for the
**Montana Alberta Tie Ltd. (MATL)
230-kV Transmission Line**

VOLUME 2 – Responses to Comments

Title: Federal Draft Environmental Impact Statement and State of Montana Supplemental Draft Environmental Impact Statement for the Montana Alberta Tie Ltd. (MATL) 230-kV Transmission Line (DOE/EIS-0399)

In this section the agencies present responses to comments received on the Draft EIS/EA issued in March 2007.

CD A-1

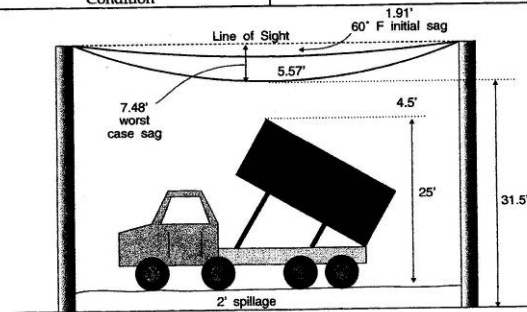
Comment 19
(Continued)

a. The basic clearance at closest approach is 18.5 feet. To this must be added the voltage adder of 4 feet (as calculated in Answer 8). This gives us 22.5' as the lowest conductor position allowed above the road under any circumstances.

b. Add the difference between worst case sag and initial stringing sag (7.5') to the required clearance (22.5') to get the required height above the road at initial installation of 30 feet.

c. Add the initial sag of 4.6 feet to get the height of the LOS above the roadway of 34.6 feet.

There are two ways to consider this problem:

METHOD 1	METHOD 2
25.0' -14.0'	18.5' -14.0'
Truck Height Included in Code Clearance (See Appendix A, Table A2)	Normal Road Clearance Reference Height for a Truck
11.0' +2.0'	4.5' +25.0'
Needed Extra Above Table Value Planned Road Elevation Change	Over the Reference Height Actual Truck Height (See Appendix A, Table A1)
13.0'	+2.0'
Total Extra Needed @ Worst Case Condition	Planned Road Elevation Change
+18.5'	
Table Value	
=31.5'	=31.5'
Total Needed @ Worst Case Condition

Response 19: See response to comment 10.

Draft Alternatives Near the Rainbow Switchyard

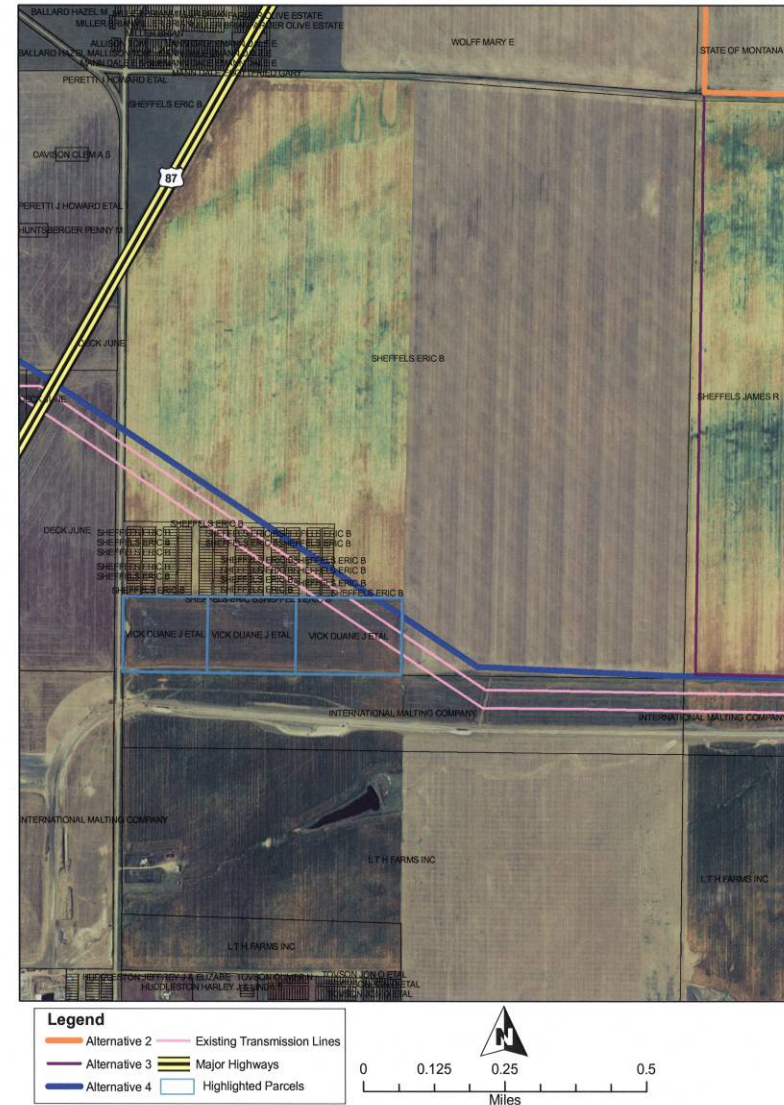
We are in the process of building a new plant and building on the properties near alternative 4 (see attached map – Draft Alternatives Near Rainbow Switchyard). If the new line went down the middle of our property it would be on top of our new multi-million plant expansion starting this summer. We would recommend the line not go through the property but around it.

Response 64: Alternative 4 is located north of the two existing transmission lines that are located on the property in Section 20, Township 21 North, Range 4 East, and on the north side of WAPA's Great Falls to Conrad 230 kV line. A map received from the Cascade County Planning office has the location of the proposed mill southwest of the existing transmission lines. See response to comment 37.
